**HIGHLANDS COUNTY
BOARD OF COUNTY COMMISSIONERS**

BID NO.: ITB 17-014 ADDENDUM No. 1

Project: **SEBRING PARKWAY EMS STATION PROJECT NUMBER: 13061**

DRAWING:
FLOOR PLAN

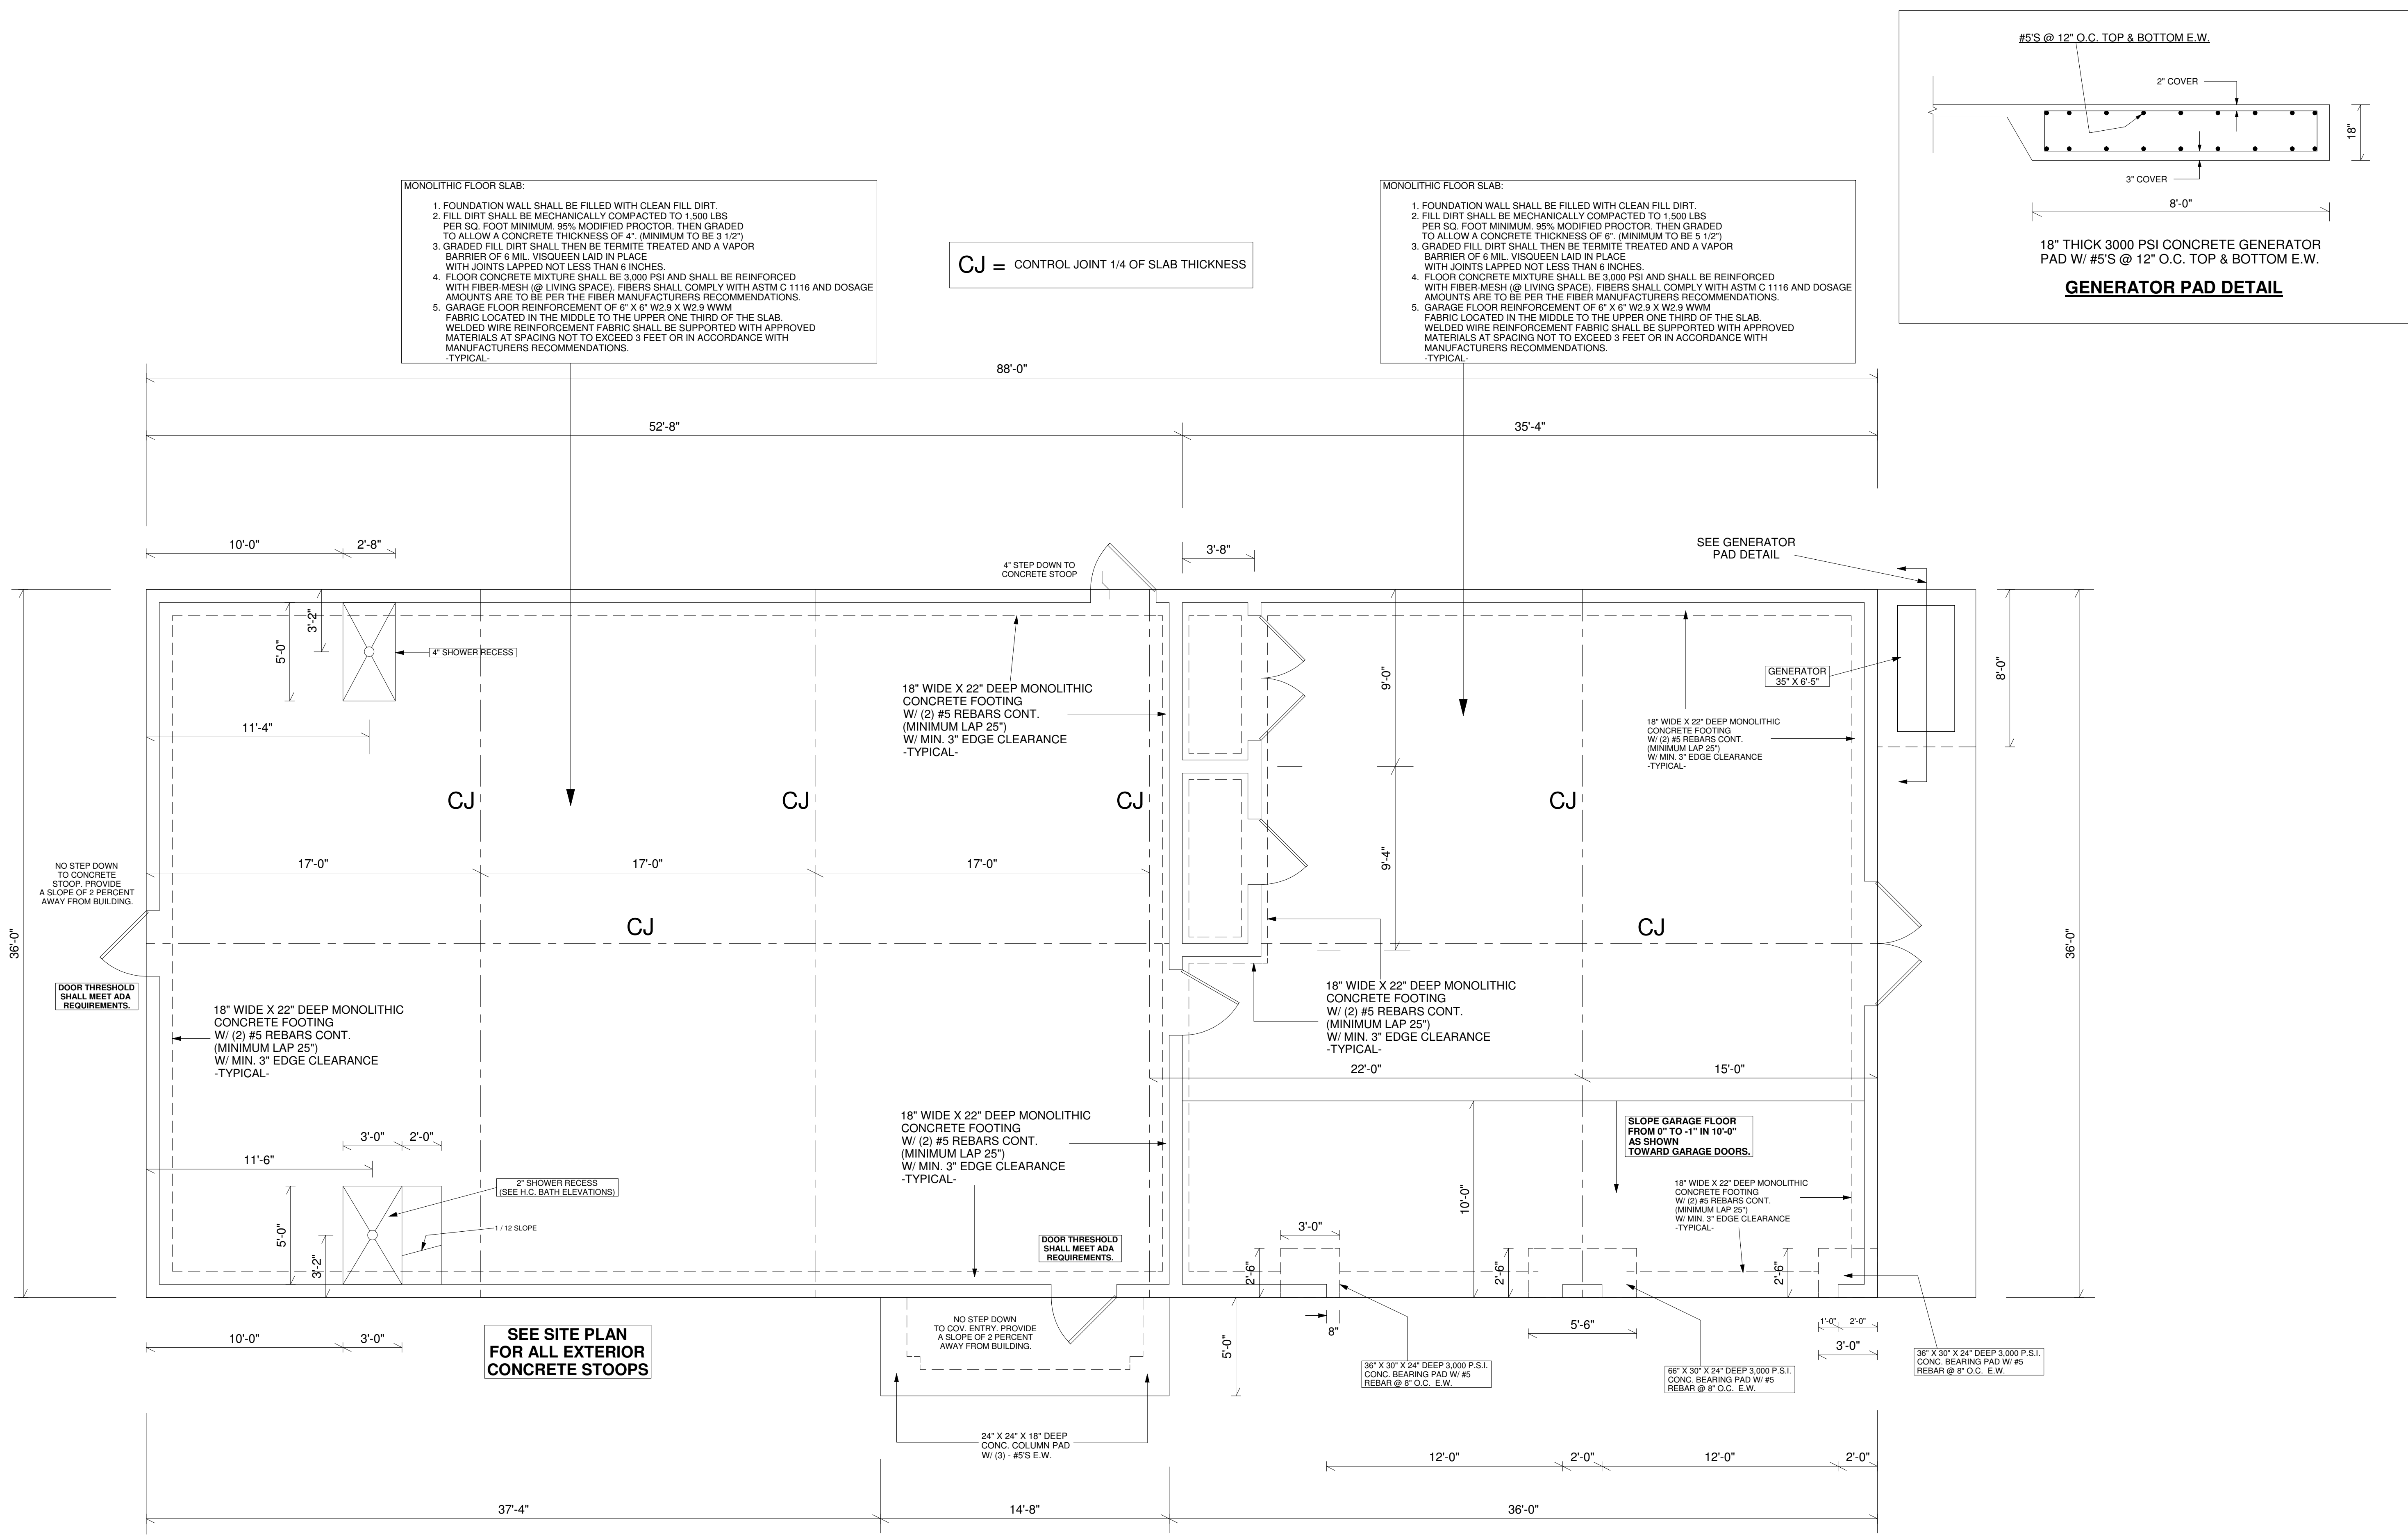
- a. The legend on the floor plan still indicates the walls to be 1-hour rated which is not required.

Additional information has been provided with respect to the construction of the interior walls.

SECTION DETAIL M-M

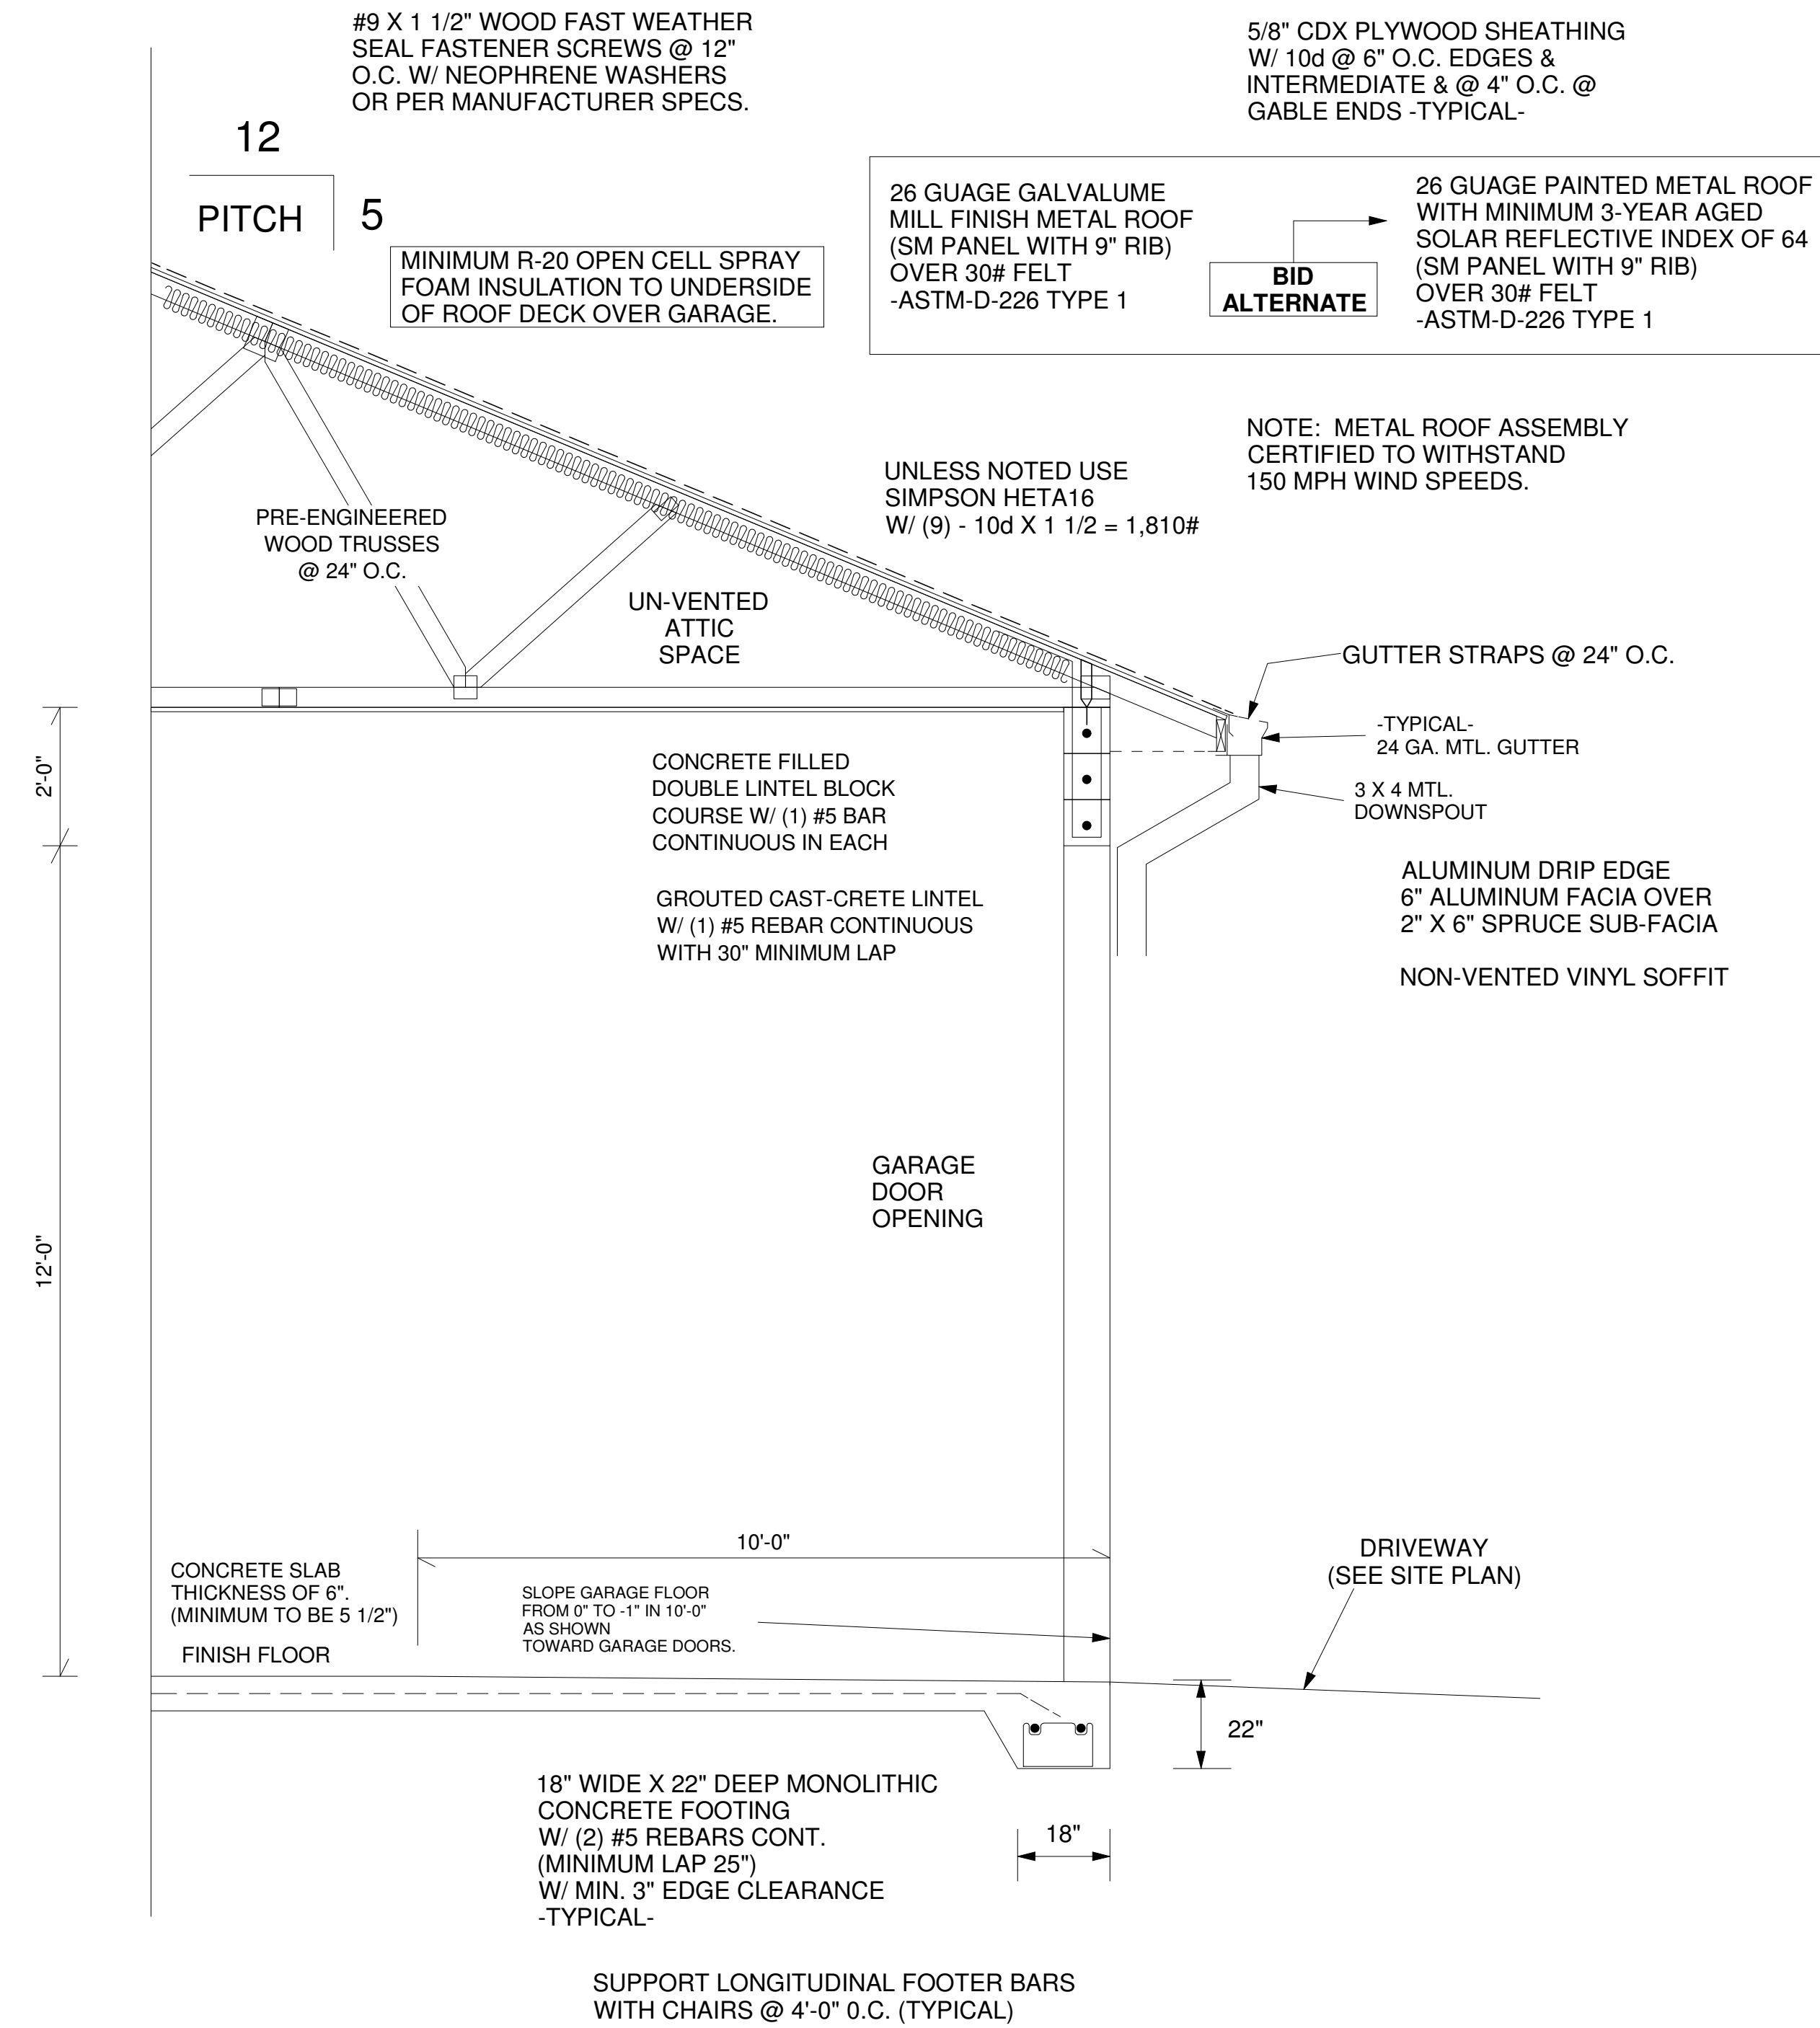
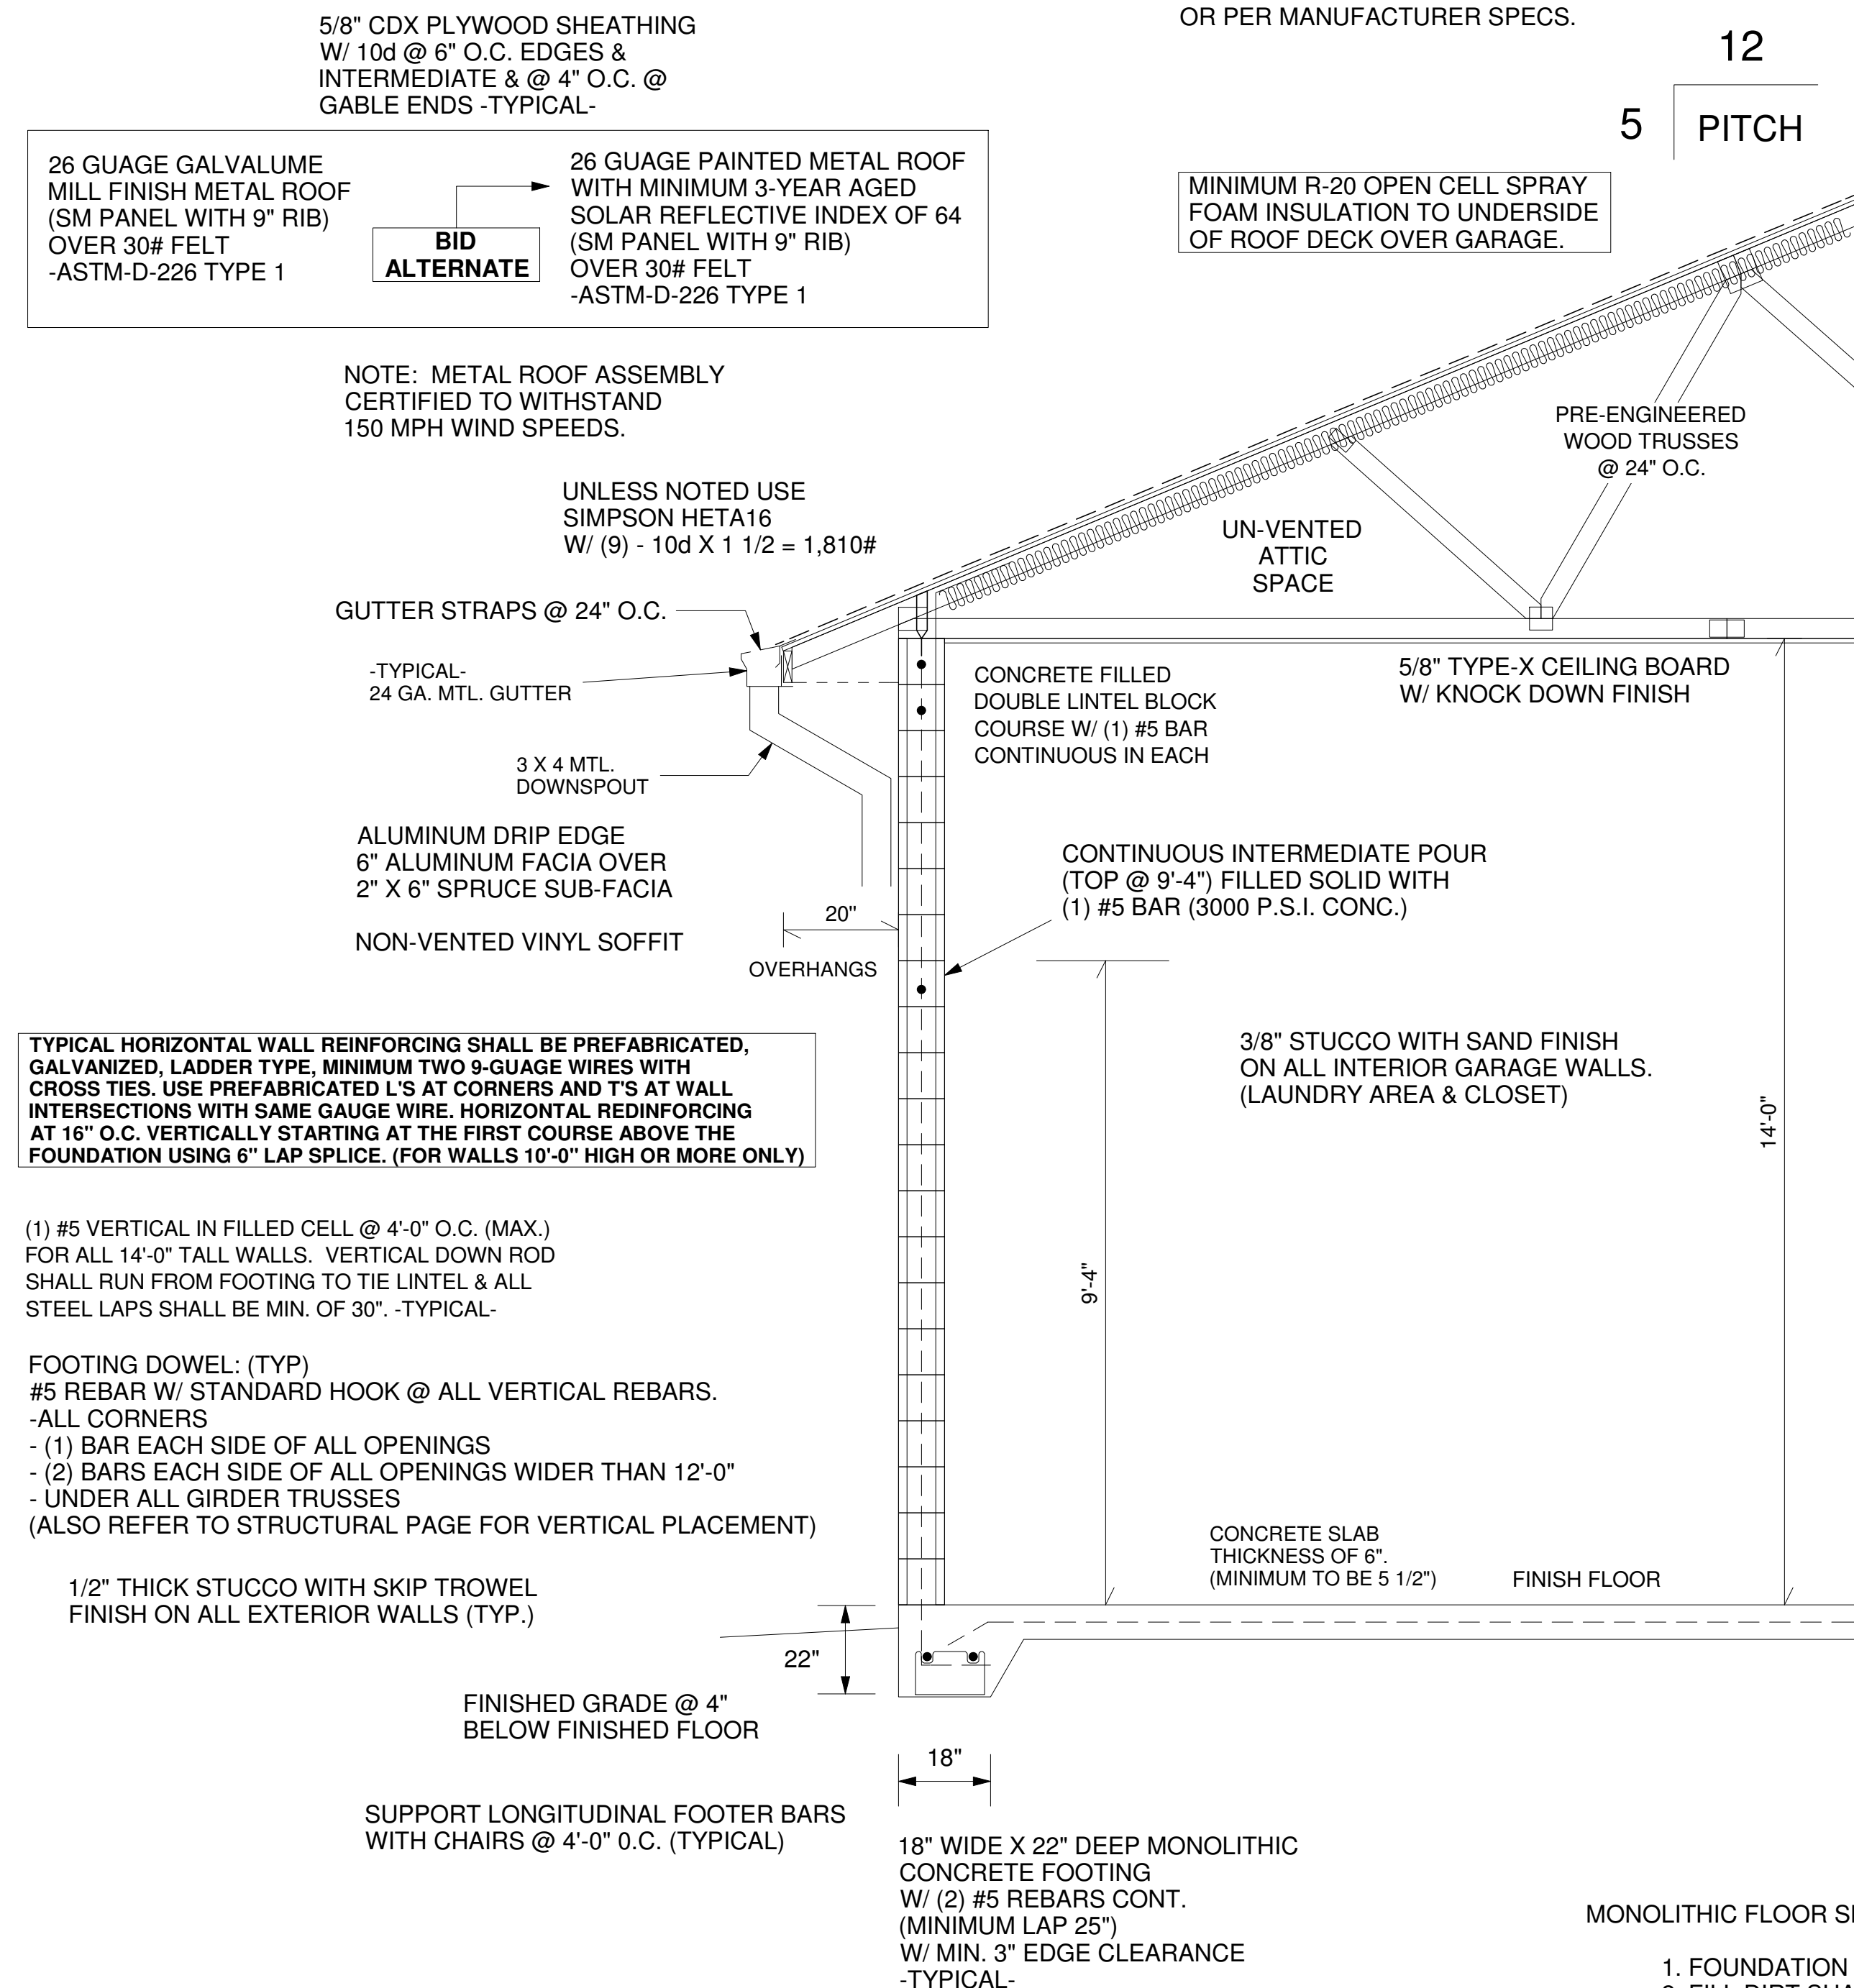
20. Sheet 7, Section M-M: Can you better explain what a cementitious sand finish is? Are you looking for a stucco finish?

A: An addition note has been added to the plans to clarify.
